**BEFORE THE PUBLIC UTILITIES COMMISSION
OF THE STATE OF CALIFORNIA**

**PACIFIC GAS AND ELECTRIC COMPANY'S SUBMISSION
OF 2021 WILDFIRE MITIGATION PROGRESS REPORT
(PUBLIC VERSION)**

**Re: 2021 Wildfire Mitigation Plan – Progress Report
(Docket #2021-WMPs)**

RESPONSE TO ENERGY SAFETY REMEDIES

FIGURE PG&E-4.5-3 PG&E: RISK MODELING CAPABILITIES IN THE MATURITY SURVEY (FUTURE STATE ~2023)

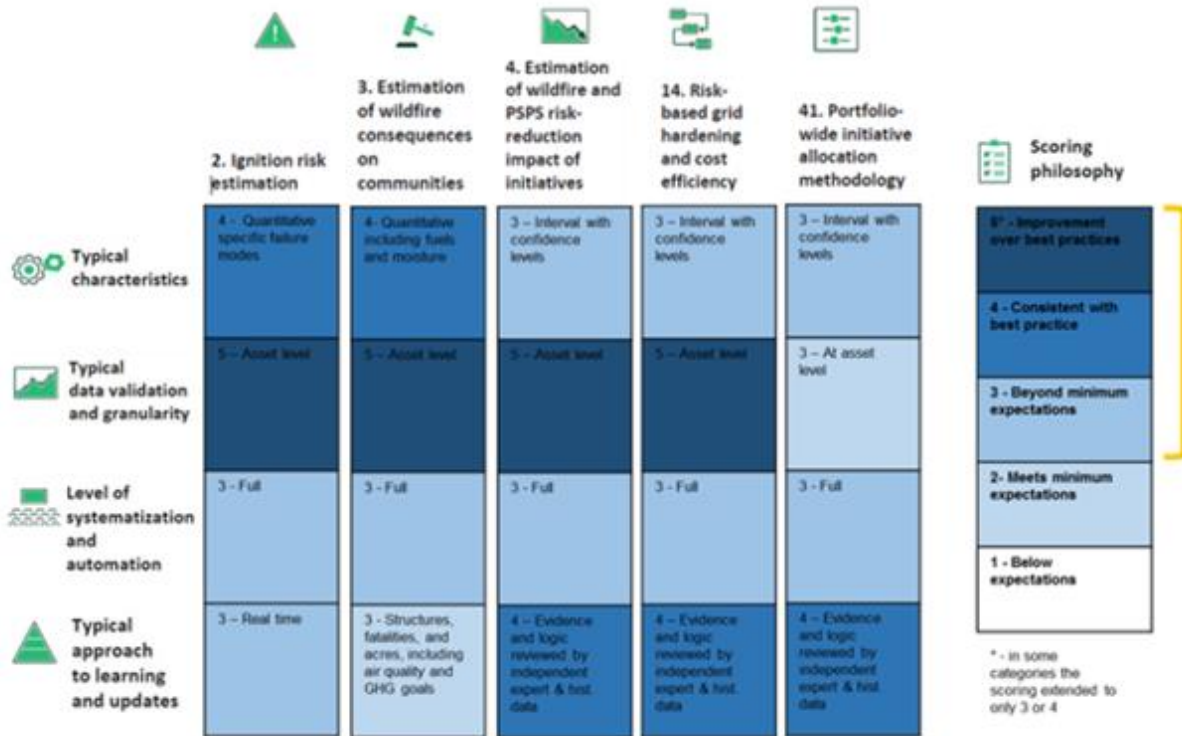
- 1) *Demonstrate that it is applying automation as quickly as possible, explaining any constraints on progress; and*
- 2) *Supply its workplan to enhance its modeling efforts.*

These improvements, as well as the development of modeling capabilities, are described in detail in our 2021 Revised WMP⁵ and summarized in Figure PG&E-4.5-3 of the 2021 Revised WMP. A copy of Figure PG&E-4.5-3 is provided below for ease of reference. The schedule for model development over the next three years is shown below for the Wildfire Distribution Risk Model (WDRM) and Wildfire Transmission Risk Model in Figure PG&E-Remedy-21-03-1 below.

**FIGURE PG&E-REMEDY-21-14-01:
MITIGATION DECISION TREE FOR SYSTEM HARDENING**

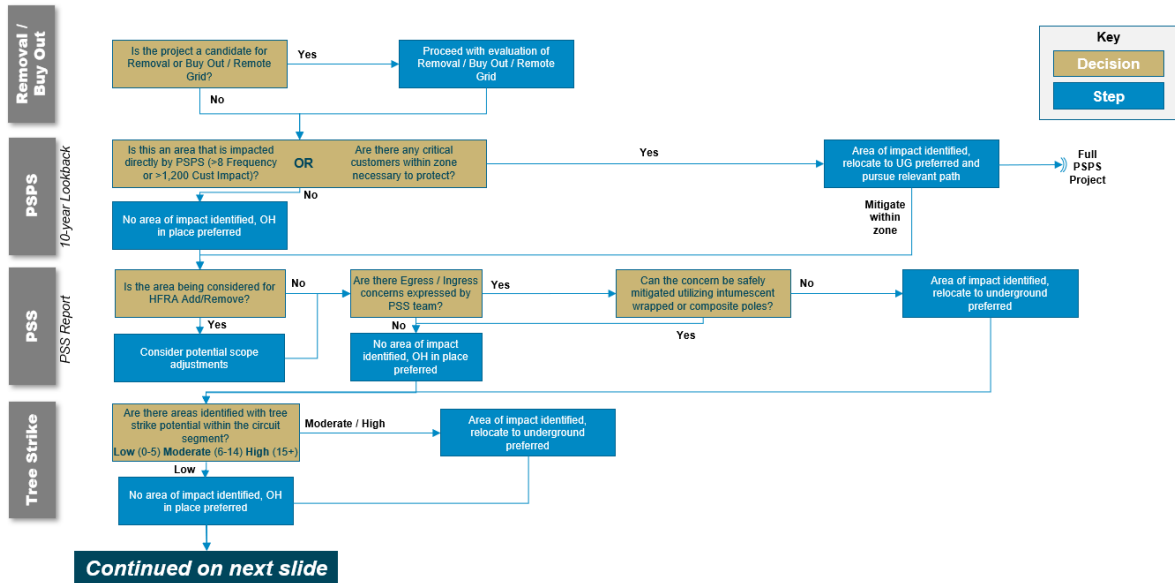
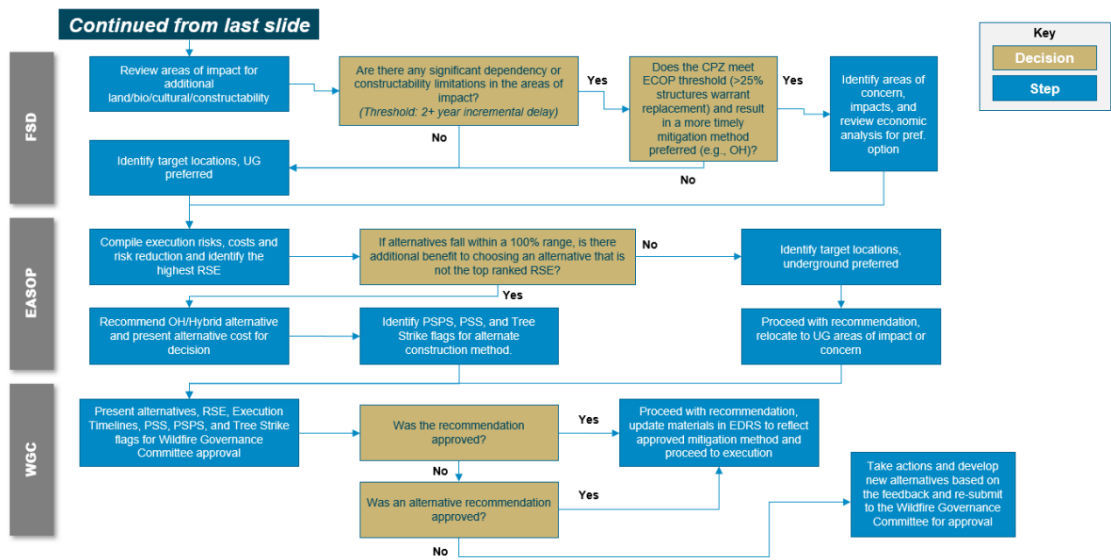
- 3) *Explain how, if at all, PG&E's recently announced undergrounding plan:*
 - a) *Changes its decision-making framework for initiative selection for individual circuit segments;³² and*

- 3) PG&E’s decision to underground 10,000 miles of its electric system will not have an immediate impact on the decision-making framework for system hardening because we are currently in the initial stages of program development. However, we expect that our decision-making framework will evolve over time as we finalize the details of the undergrounding program. For System Hardening Program projects through 2023, we have used the existing decision-making framework, which is depicted in Figure PG&E-Remedy-21-14-01 below.
